Functional Differences Between MSC8101 (Mask 2K42A) and MSC8103 (Mask 2K87M)

This document describes the differences between MSC8101 mask set 2K42A and MSC8103 mask set 2K87M. These differences include:

Figure 5. MSC8103 Clock Functional Block Diagram for 2K87M Mask Set

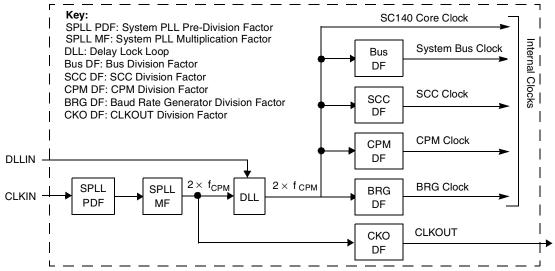
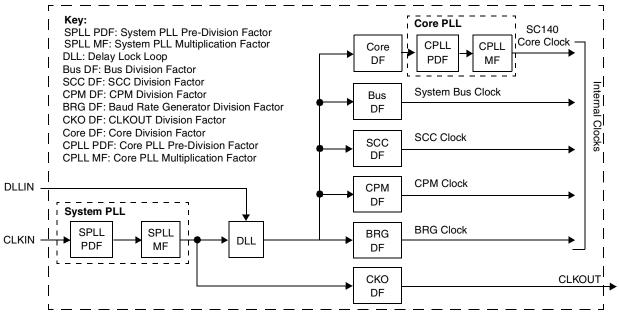
Figure 5 shows the functional block diagram for the 2K87M mask set. The 2K87M mask set contains an internal system phase-lock loop (SPLL) and a core phase-lock loop (CPLL).

SPLL PDF, SPLL MF, Core DF, CPLL PDF, CPLLMF, and CPM DF are determined by the clock configuration mode; Bus DF = CKO DF and is determined by the clock configuration mode; SCC DF is always 4; BRG DF is set by the System Clock Control Register (SCCR) and is 4, 16 (default), 64, or 256.

Figure 10. HDI16 Host Request Structure

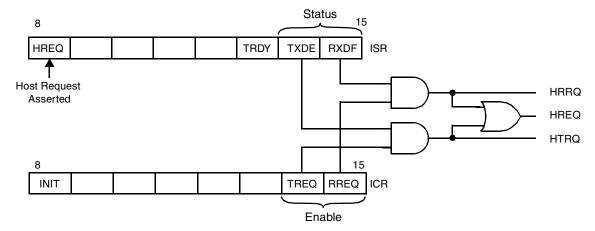
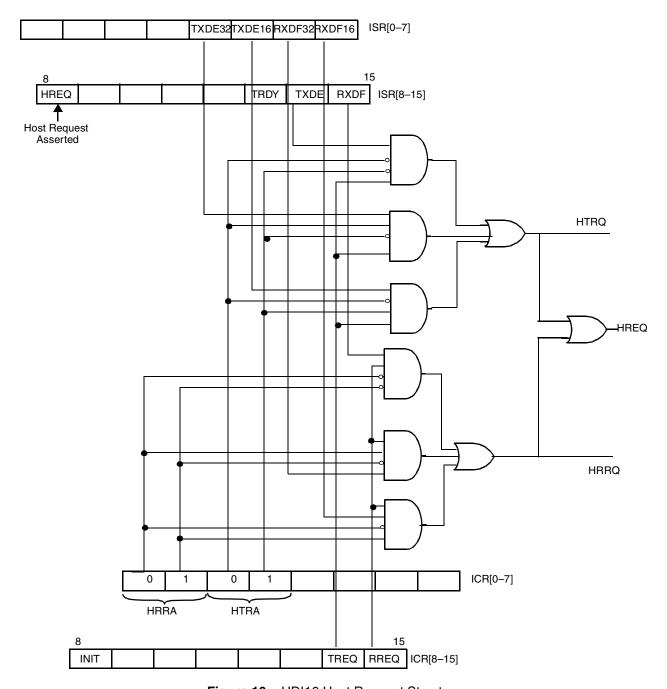
When HREQ is connected to the host processor interrupt input, the HDI16 asserts HREQ to request service from the host processor. HREQ is asserted according to the programming of ICR[HTRA] and the status bits TXDE, TXDE16, and TXDE2 when ICR[TREQ] is set, or according to the programming of ICR[HRRA] and the status bits RXDF, RXDF16, and RXDF32 when ICR[RREQ] is set, as **Figure 10** shows. The programming of HRRA or HTRA chooses the status bit, and depending on its value, HREQ is asserted or deasserted.

Figure 11. 2K42A Mask Set 24 KB Dual-Port RAM Memory Map

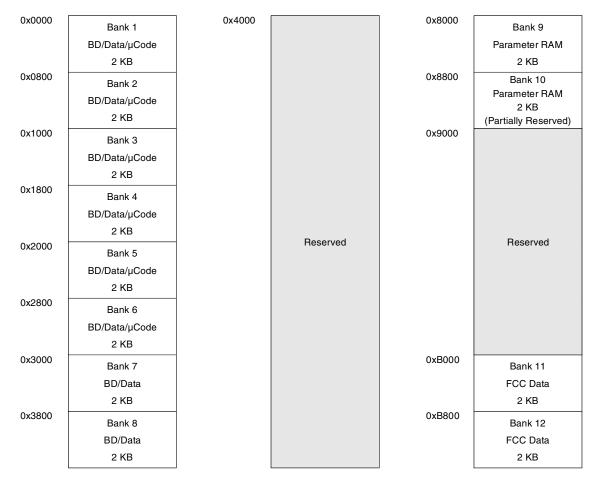
Figure 11 shows the MSC8101 2K42A mask set memory map of the dual-port RAM.
